MAITLAND CITY CLUB

ACCESS ASSESSMENT REPORT

Maitland City Club – 14 Arthur Street, Rutherford

Report Type: Access (Development Application)

Figure 1 - The proposed accessible bathroom on the Lower Ground Floor.

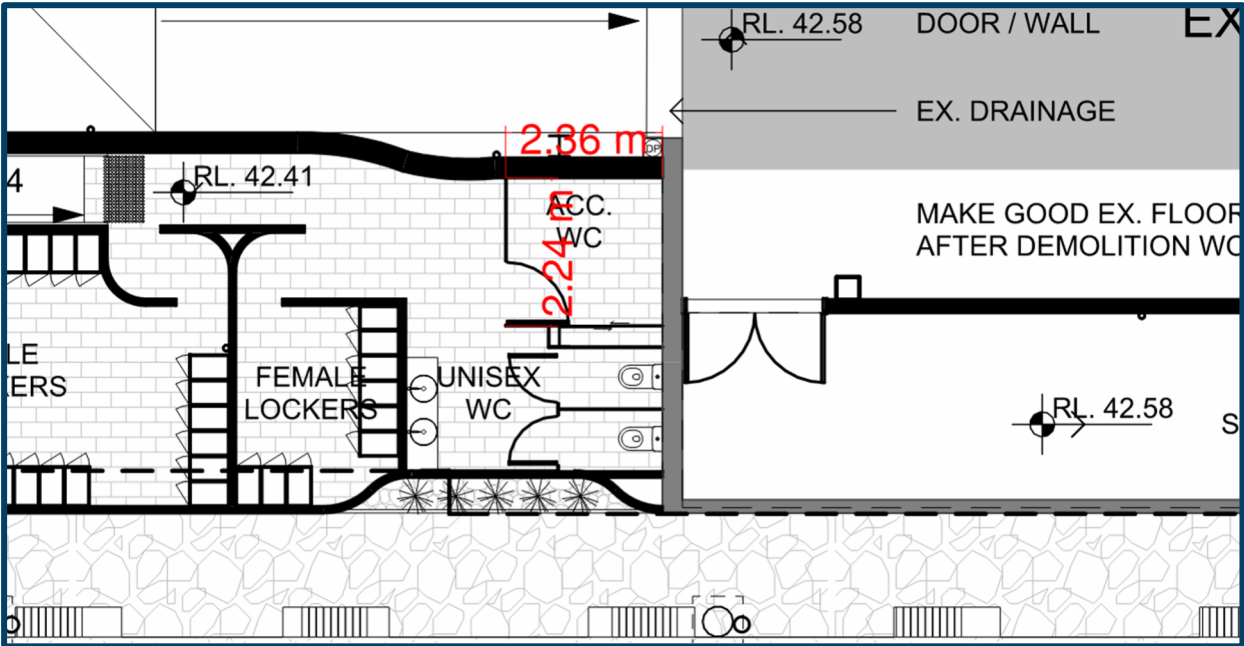
The proposed accessible bathroom on the Lower Ground Floor will be required to increase to no less than 2300 x 2340 mm to comply with Clause 15 of AS1428.1. The increased dimensions will allow a shower and provide construction tolerances to ensure that the minimum floor area is not compromised during Construction.

Figure 2 - The unisex facilities on the Lower Ground Floor

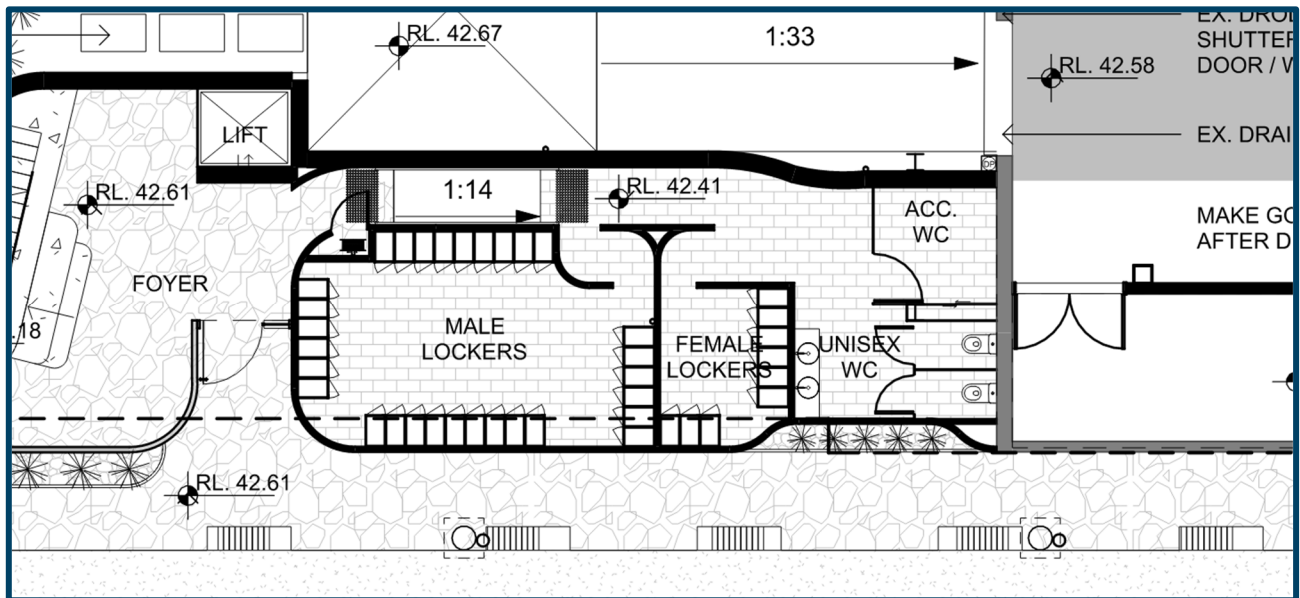
It will be necessary to ensure that separate male and female ambulant sanitary facilities within the Lower Ground Floor facilities are provided. The current design shows that these facilities are unisex (BCA Report

117581-r1 recommends a Performance Solution to provide shared facilities). However, it is recommended that these facilities are provided as ambulant.
